Zoning Staff Report

Case Number: SP-22-013

ZONING SITE PLAN FOR HYBRID TRACT AT PRIMROSE STATION
CITY PROJECT NO. SP-22-013
43.61 ACRES IN THE J. HEATH, J. ASBURY, A HODGE SURVEY
CITY OF FORT WORTH, TARRANT COUNTY, TEXAS

ZONING SITE PLAN
SP-22-013

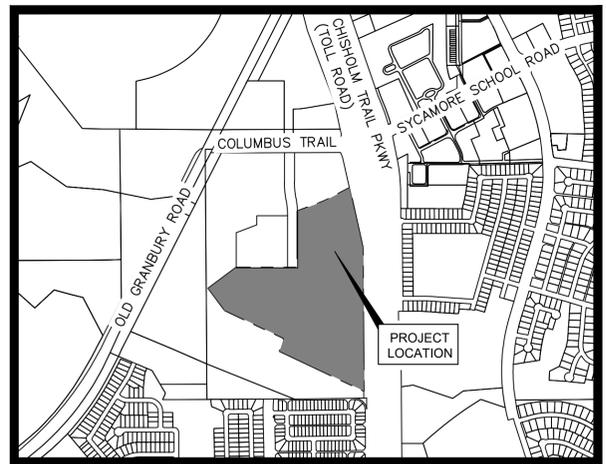
- Add case reference SP-22-013.
- Can remove legal descriptions from Site Plan if additional room is needed.
- Revise note on enhanced landscaping from “Section 6.301” to “Section 4.711.d.6”.

- Add note “All parking spaces will meet the minimum dimensions in §6.202, Zoning Ordinance”.
- Label zoning of all adjacent properties.
- Label zoning of subject property “PD 1247”.

- Label 6.0 acre park as ‘private park’.
- Relabel Streets as Fire Lanes, unless these are planned to be platted and dedicated as public rights of way.
- Typo in Parking Data Summary Table ‘1 space per Bedroom’.

- Show setbacks for buildings near Brewer Boulevard. Must meet 20’ front building setback.
- Show setbacks for buildings on rear property line of Lot 1 Block C. Must meet 5’ rear building setback.

- Add legend for building types, or differentiate cottages/duplexes/multifamily buildings in a clear manner.
- Add information regarding building height & number of stories for each building type.

- Height cannot exceed 36’ in PD-1247 zoning (base “C”, no development standards for height).
- Zoning labels on adjacent properties are wrong and some parcels are missing zoning – revise.
- Brewer Blvd. front setback of 20’ not clearly depicted on both sides of the road on Site Plan.
- Site Plan is too busy – consider removing floodplain information, legal descriptions, electric/bicycle parking, offsite easements/improvements, or some other non-essential elements. Or you can add separate exhibits, for example showing Open Space calculations (see example attached).

1. Show Access to Public park

2. Gated entrances into secured areas must be designed in accordance with TPW’s “Traffic Engineering Design Standards and Policy Guidelines”. Provisions for an acceptable turnaround must be made. Provide details in IPRC plan set (single-family) or UR site plan (multi-family) for gates. All gates shall be equipped with a knock-box or other approved fire access apparatus that is reviewed and approved by the Fire Department. (Gates must be located 3 vehicle lengths from the ROW).

3. Sidewalks and Street Lights_ Sidewalks and street lights are required for all public and private streets as per City of Fort Worth Standards. Show 10' sidewalks along frontage.

Two points of platted and constructed (referencing the proposed/future lanes) access required for multi-family development having more than 100 units.

Vehicle gates are required to be a minimum of 20' wide when fully opened and equipped with Knox Locks.

Internal Emergency Access Easements must be named and platted for addressing.

Hose lay must be provided to all exterior walls of each building (including cottage units) within 150', measured along a 5' wide unobstructed path. Hose lay MAY be increased to 300' for sprinklered buildings. Hose lay should be calculated around garage units, not through them unless they have no exterior walls. There are a few buildings that fall short of the 150'.
